Mississippi State University
Invitation for Bid 23-15, Composite Ply Cutter
Addendum One

January 24, 2023

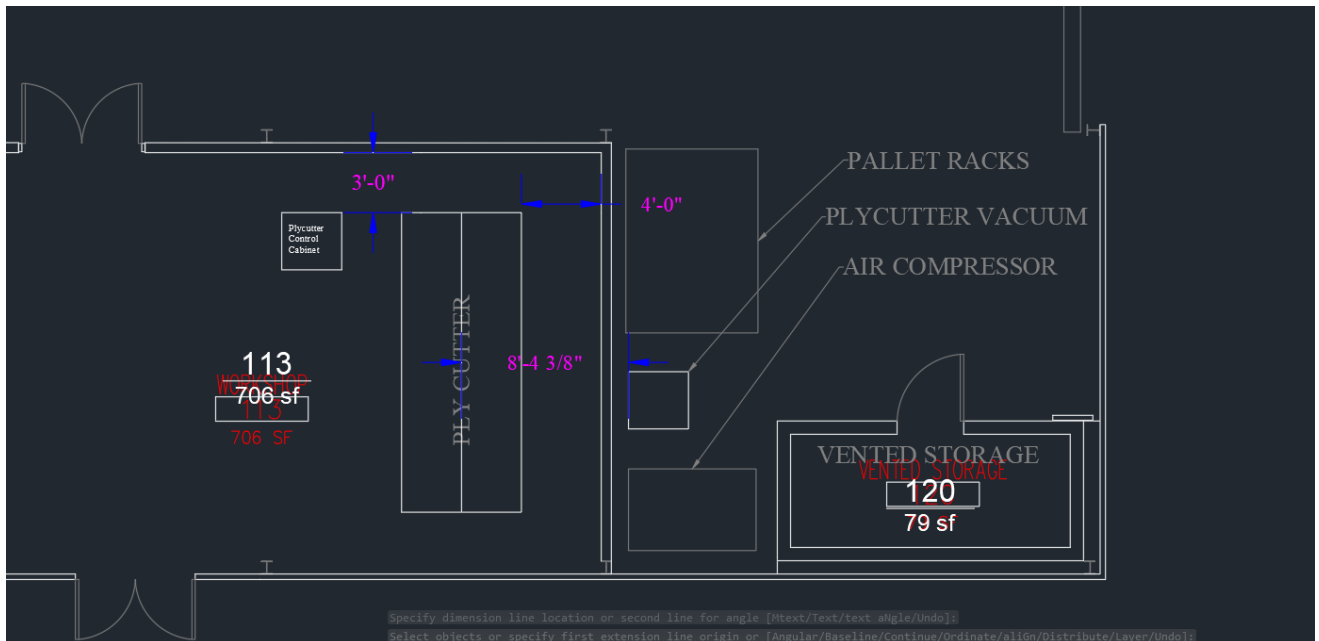
8. Regarding the vacuum system. As standard with our design, the blower is within and beneath the table structure. With that said, is it still desired to install the blower externally? If so, please provide a drawing or sketch showing the location and dimensions and distance of where the blower will be installed so we may properly quote additional components. If installed externally, will the plumbing be installed above ground or below ground in a trench? What is the intent of installing the blower externally? Is it noise reduction? Reduction of footprint?

- a. If possible, ACI would like to mount the vacuum system in a separate location from the table unit as we are concerned about noise levels in a closed room. The proposed location of the vacuum system is shown below. Alternatively, the vendor may quote alternate noise reduction system and keep the vacuum located under the table. It is desired to keep ambient vacuum noise levels under 80dB during the machine operation.
